**ADDENDUM  
NO. 1**

**January 11, 2023**

**Three Rivers Community Schools – Three Rivers Middle School Additions and Renovation**  
**1101 Jefferson Street**  
**Three Rivers MI 49093**

**ADDENDUM 001**

**UNIT 'B' ROOF FRAMING PLAN**  
1/8" = 1'-0"

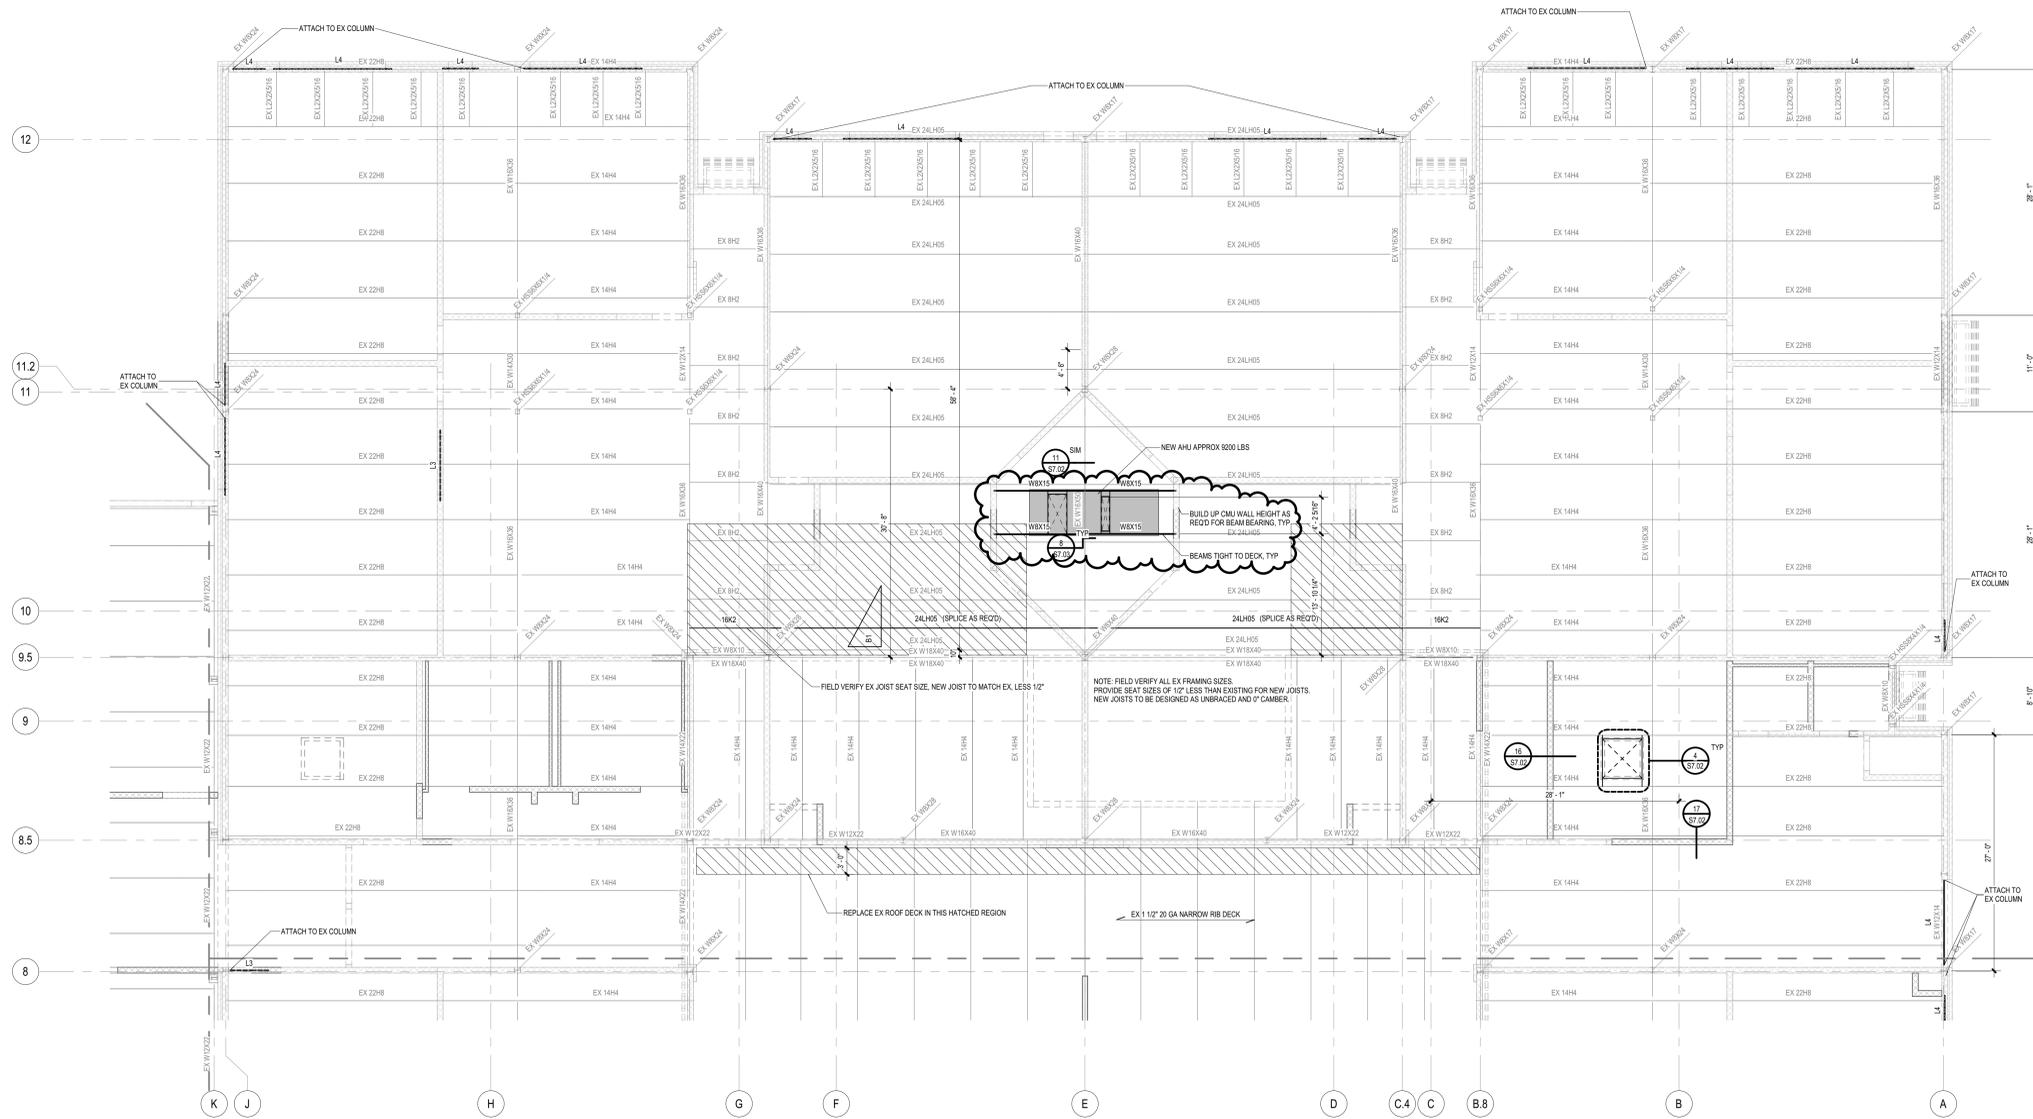
### **ITEM NO. 1     SHEET S3.1B - UNIT 'B' ROOF FRAMING PLAN (REISSUED)**

- A. Added beams to support roof top unit.
- B. Added note to build up CMU wall as required.
- C. Added section cut for 8/S7.0.

**8**  
**S7.03** FRAMING DETAIL  
3/4" = 1'-0"

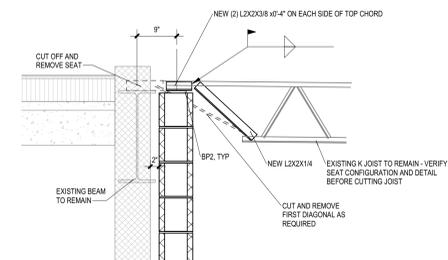
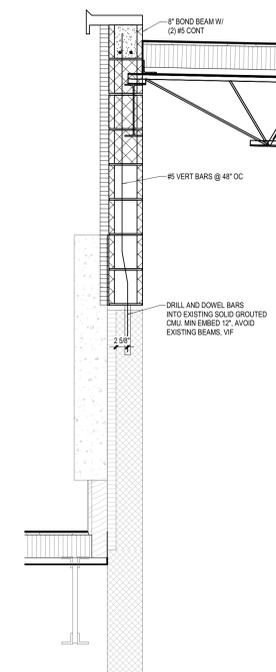
### **ITEM NO. 2     SHEET S7.03 – ROOF FRAMING DETAILS (REISSUED)**

Added Detail 8.
